Original 2005 proposal and drawing shown at 2007 Public Information Centre, Alternative 1 (now referred to as Option 1)

Cropped section of Alternative 1, General Arrangement (Option 1), from Page 2 of Appendix A of Environmental Screening Report

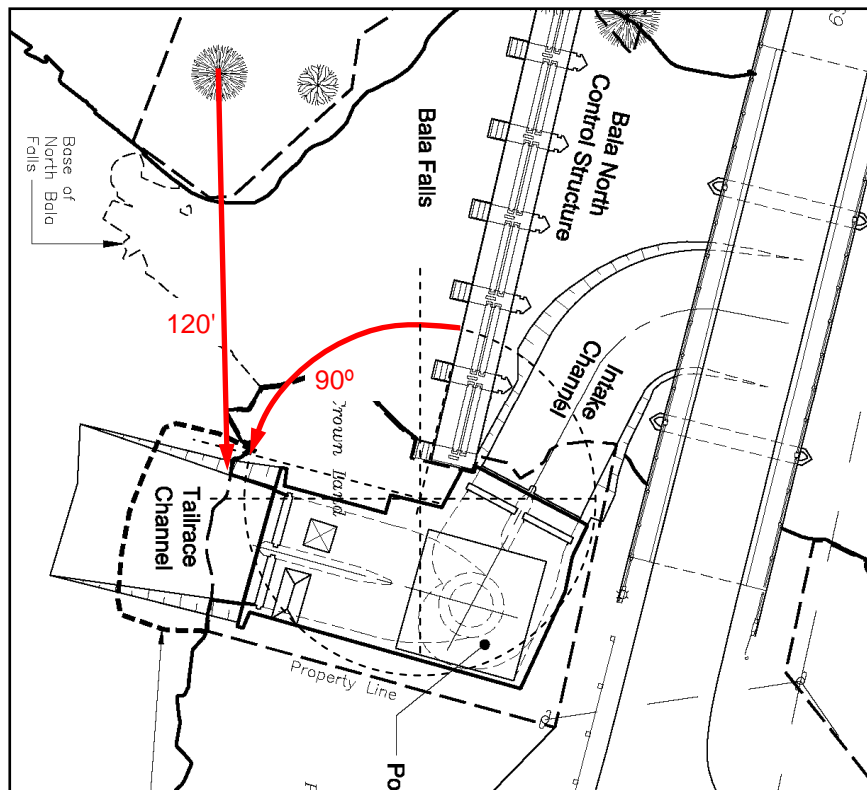
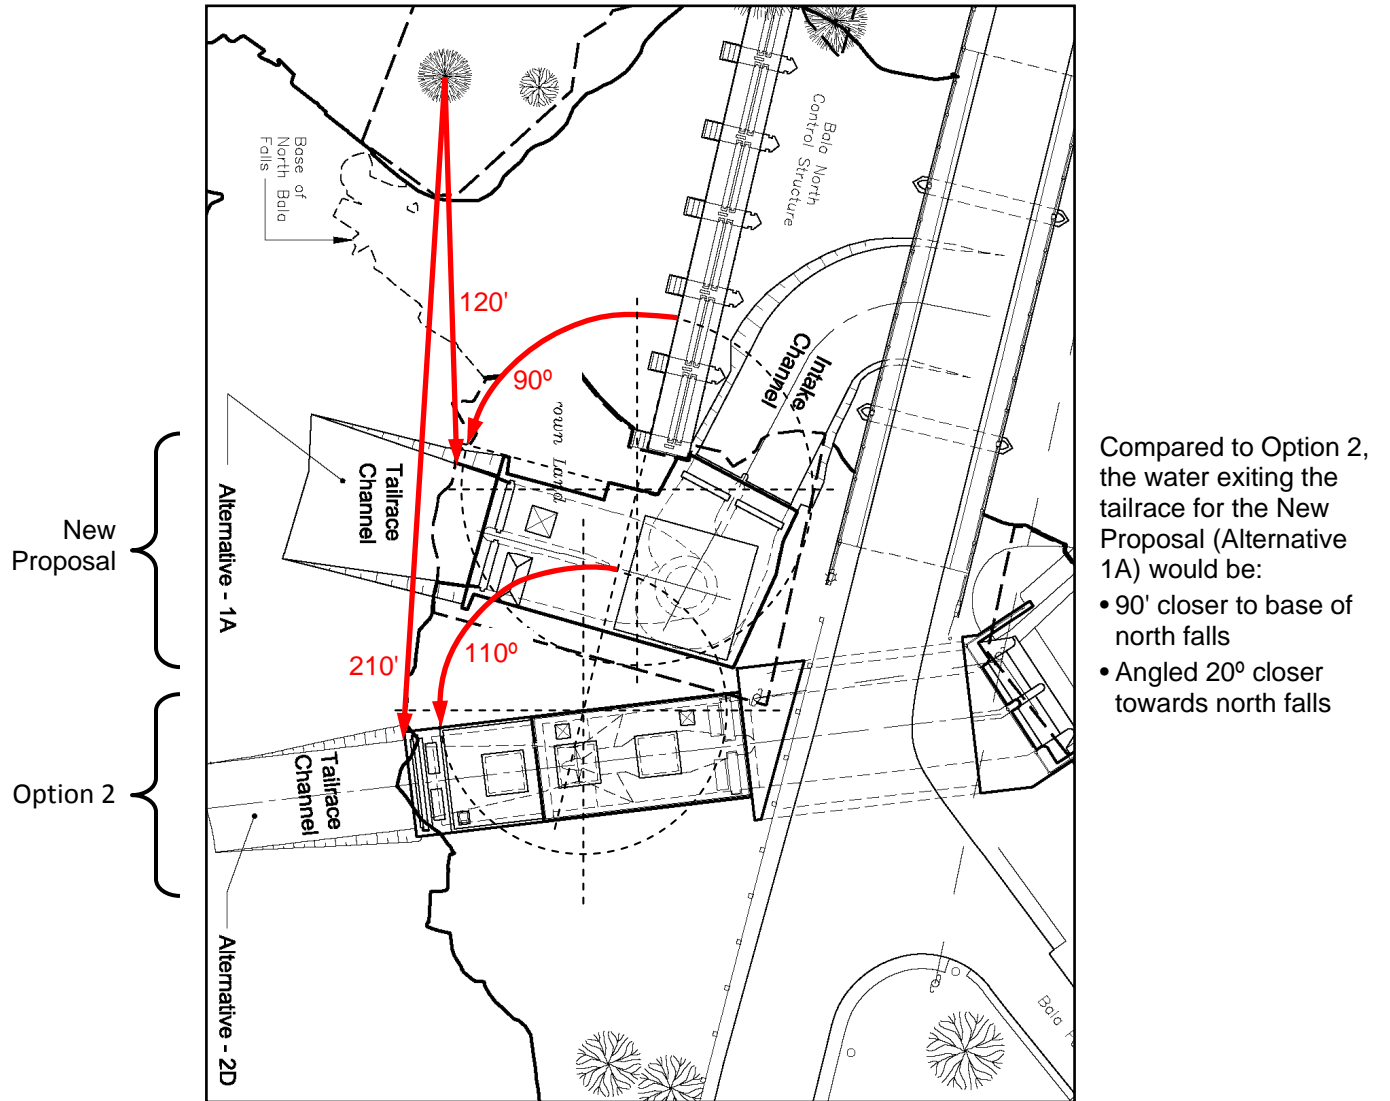
Compared to Option 1, the water exiting the tailrace for the New Proposal (Alternative 1A) would be:

- More than 60' closer to base of north falls
- Angled 45° closer towards north falls
